Subject: RE: Zia Hills Spill

The 1RP for this incident is

30-025-	26S-32E-	
5235	10/16/2018	А	Conoco Phillips	Red Hills Federal Com 401H	42560	25B	10/3/2018

Also, below is a snip-it of the spill volume calculator that was used to determine the volume of fluid that left the pad.

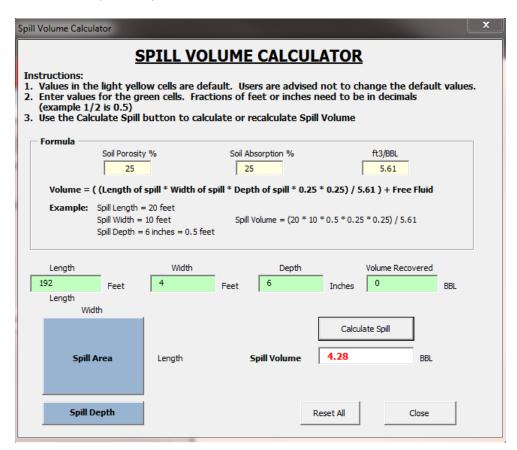
Thank you for providing the calculations to determine release volume. Please have Conoco Phillips's Environmental Department provide the rationale for setting the proportion of soil absorption at 0.25 and soil porosity at 0.25.

In an idealized soil, 50% is pore space and 50% is solid material. Of the 50% pore space, approximately 25% is filled with air and 25% with water. In other words, 0.25 could be interpreted as free available pore space (porosity) for spill fluids to fill and 0.25 as not available since these pores are filled with water for vegetation. As the soil porosity is set at 0.25 and the spill saturated a depth of 0.5 ft., the assumption is 100% of the 0.25 porosity has been filled with the water-based mud. However, with the soil absorption proportion set at 0.25, the interpretation of the equation is that only 1/4 of the 0.5 ft. depth entered the 0.25 pore space. Is there an misunderstanding or misuse of the term 'soil absorption'?

- 1. The GPS coordinates as written is not in the vicinity of the API well provided.
- 2. The release volume for spill calculation should include both the impact on location and the portion that impacted pasture. According to NMOCD database, the entire release area is on Federal surface and minerals.
- 3. Dated, geo-referenced photo documentation for verification that the initial response activities have been employed to contain the release is requested.
- 4. Per 19.15.29.10 NMAC, a major release necessitates immediate notification to NMOCD Environmental Bureau chief (cc'd), in addition to the appropriate District office.
- 5. Per 19.15.29.13 NMAC, regulations of corresponding agencies supersede NMOCD's.
